LIMESTONE REVISIONS NOTE:

DOUGLAS STREETSCAPES

TOWER DETAILS

LS 6.03
SHEET/OF

3 TYPICAL ELEVATION

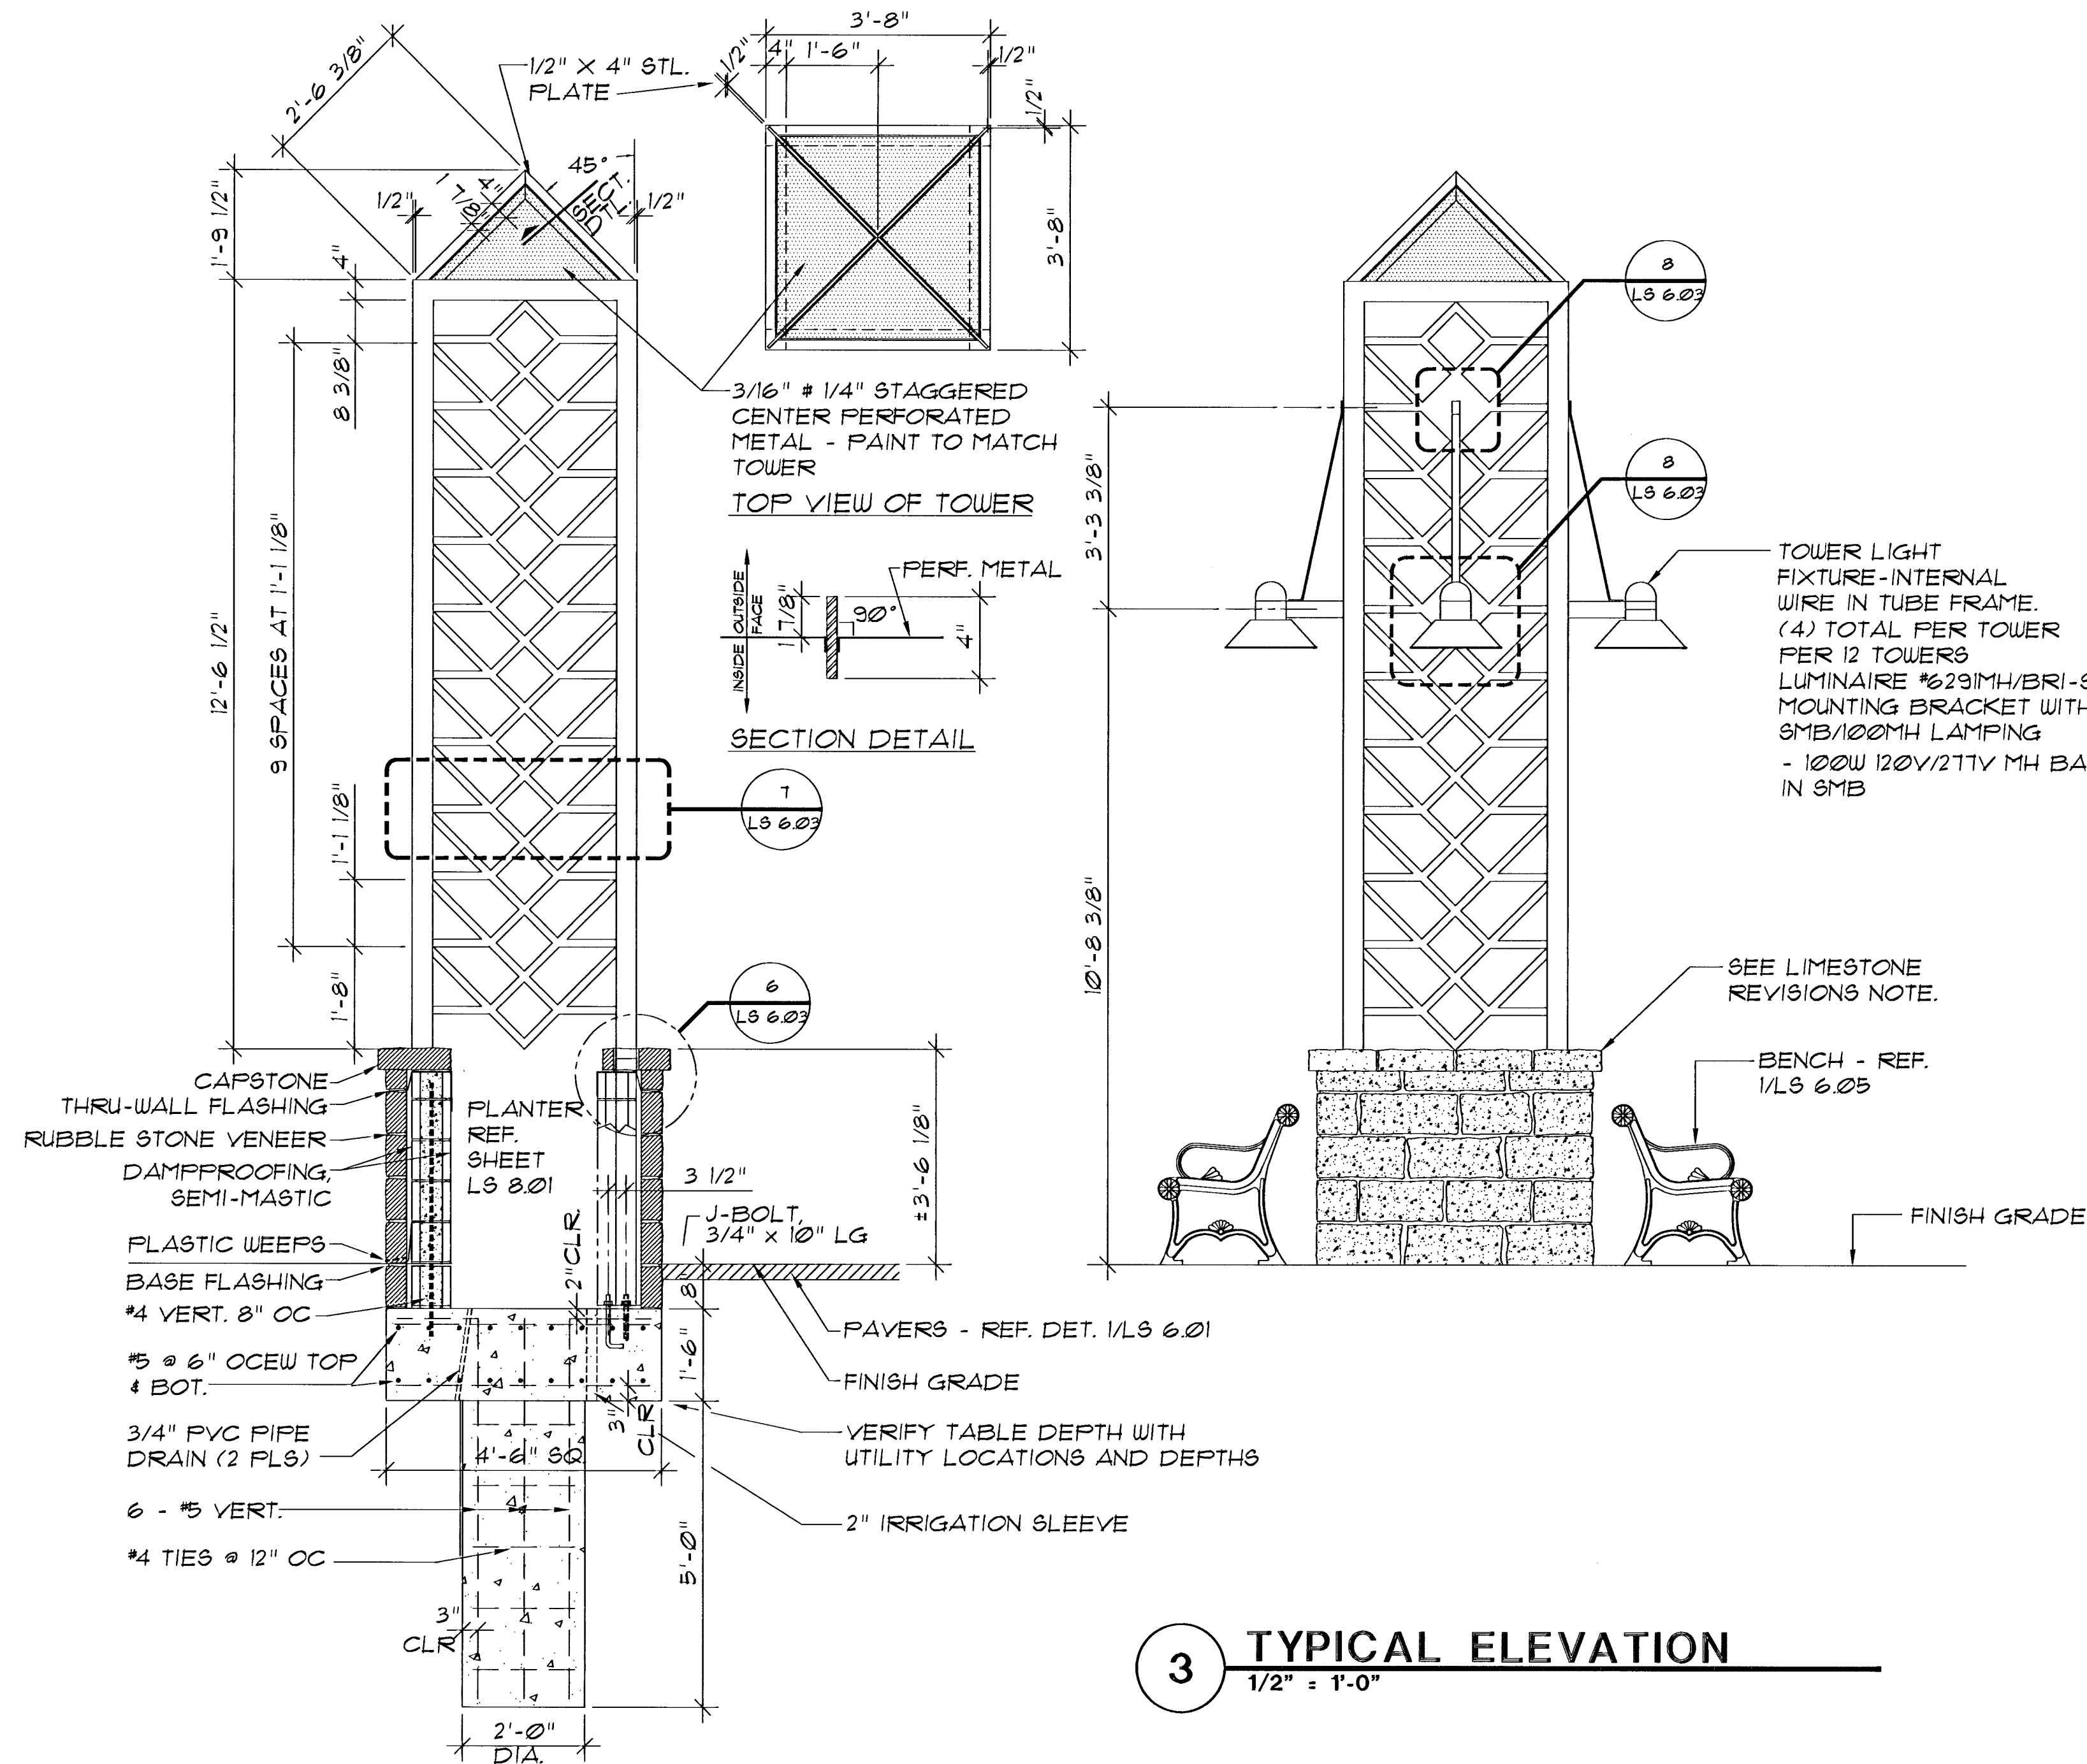
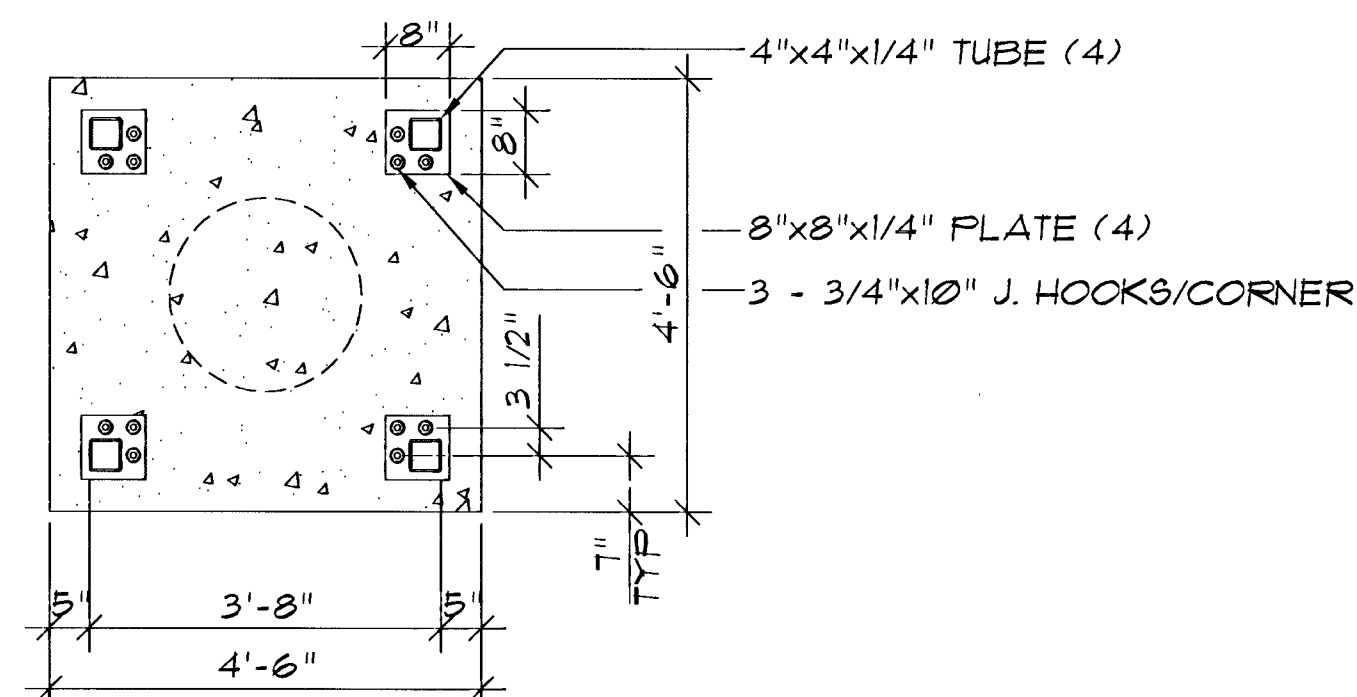
Annotations to Specifications, Section 04210 Stone Masonry Work, Part 2.00 Materials, 2.01 Limestone, and Drawings Sheet LS 6.03.

In lieu of Rubble Limestone, the stone veneer pattern is to be of approximately equal 8" height horizontal courses, with random 12" to 18" ± face lengths with staggered vertical joints. Texture of face and ends where exposed shall be Natural Cleft, Pitched Face. Bed thickness to nominal 3 3/4" ± 1/4".

In lieu of the 4" height (vertical dimension) cap stone, provide 8" height cap stone, with Natural Cleft, Pitched Face, texture on face, and ends where exposed. Texture on top surface of cap stone to be Natural Cleft, Pitched Face if possible or Split Face is acceptable on the top surface. The face of the cap stone is to be in approximately the same plane as the stone face below versus the 1 1/2" overhang as detailed.
